Issue	Comment
Traffic and transport	
<p>There is inadequate public transport to support the additional population. Site does not have good access to public transport as claimed and services are at/over capacity in peak, both buses and light rail.</p> <p>Purported use of the light rail by residents of the site is unlikely given the 20 minute walk to Lilyfield stop.</p>	<p>The traffic report dated April 2019 suggests there are 25-30 bus services between a two-hour period. It should be noted that some of these services do not have destinations in the Sydney CBD and consideration of services across a two-hour period is inappropriate. The existing patronage should be assessed to identify the current capacity during commuter peak hour.</p> <p>The traffic report considers that a proportion of future residents on the site will travel to work by train and ferry. Due to the site's distance from train and ferry services, these residents should be included in the bus patrons.</p> <p>It is unclear where the data for journey to work and residents with a job has been sourced from and from what year.</p>

Figure 2. Illustrative cross sections from Urban Design Report. Balmain Road is to the left, Fred Street to the right. Site is shown flat and has not accounted for a 2.5 m to 3m fall to Fred Street.

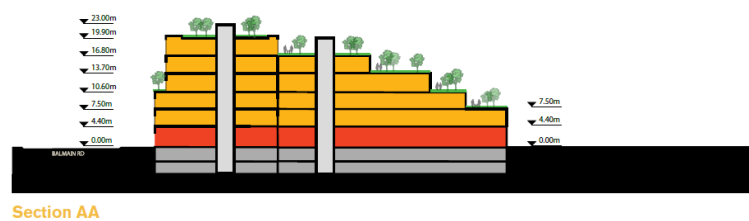
<p>The existing road network cannot adequately accommodate the additional traffic and parking generation.</p>	<p>It is unclear where the residential traffic generation rates have been derived from and the forecast traffic distribution has not been justified. Further details should be provided regarding the rates used in the assessment. It is also unclear when the existing weekday morning, weekday afternoon and Saturday midday traffic volumes were undertaken.</p>
<p>The intersection of Cecily and Balmain is already dangerous.</p>	<p>Although SIDRA may have indicated that the intersection performance is of an acceptable level of service, without the summary report, the degree of saturation and queues that may result from the additional traffic is not clear.</p>
Urban design	
<p>The site layout and building design presented in the supporting Urban Design Report do not adequately respond to Gateway Determination condition (g) that requires "rationale for the height, floor space ratio, building massing and modulation for the site".</p> <p>The justification provided for the built form is unsatisfactory.</p>	<p>The submission is agreed with. The exhibited "Design Concept" has not sufficiently documented how an industrial use would be catered for. This includes:</p> <ul style="list-style-type: none"> - not making allowance for ground level functional areas which are not counted as Gross Floor Area and which affect approx. 25 percent of the site area (see Figure 1 below). It is not acceptable for servicing to be an afterthought. - not showing how the minimum 6000sqm of industrial floor space will be achieved. Due to the above, an additional storey of approximately 1000sqm will be required. It was on the basis of a minimum 6000sqm of industrial floor space that the Planning Panel stated support for the Planning Proposal on 12 October 2017. - the minimum floor to floor height established to enable a functional adequate and flexible industrial use backed up with extensive technical design information. - the site falls to the rear between 2.5 m to 3.5 m, whereas the Design Concept depicts a flat site (see Figure 2 below). <p>The above matters in turn influence the layout of the upper</p>

level residential component and would lead to a different built form outcome to what is depicted in the Design Concept.
